**CITY OF WINTER GARDEN  
DEVELOPMENT REVIEW COMMITTEE  
MINUTES  
September 14, 2022**

The Development Review Committee (DRC) of the City of Winter Garden, Florida, met in session on Wednesday, September 14, 2022 in the City Hall Commission Chambers.

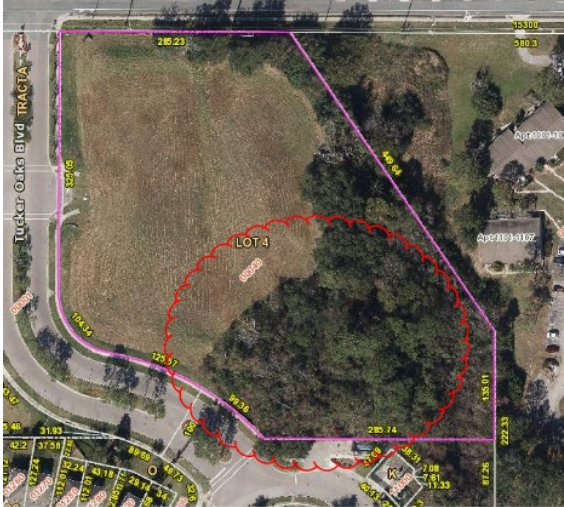
- 2. **Repeat comment: It appears a bald eagle’s nest is located on this property. Show location including required protection zones (330’ & 660’ radii).** Applicant will revise the plans to include circles of protected zones.
- 7. **Any new water, sewer, or irrigation connections are required to pay utility impact fees, to be paid prior to issuance of site or building permits or execution of FDEP permits. The plans currently show twelve 1” potable meters – please confirm. Assuming a 1” potable meter and 2” irrigation meter the following impact fees will be due:**

- 8. **The above impact fee calculation is only for Phase 1. Additional future meters are shown which will require impact fee payment at this time. Provide a tabulation of all meters for future phases including anticipated sizes, including irrigation meters. Connection to existing reclaimed lines is required.** Commercial payment is all up front.

The Applicant noted that there will be a total of six water meters on the site for the future development.
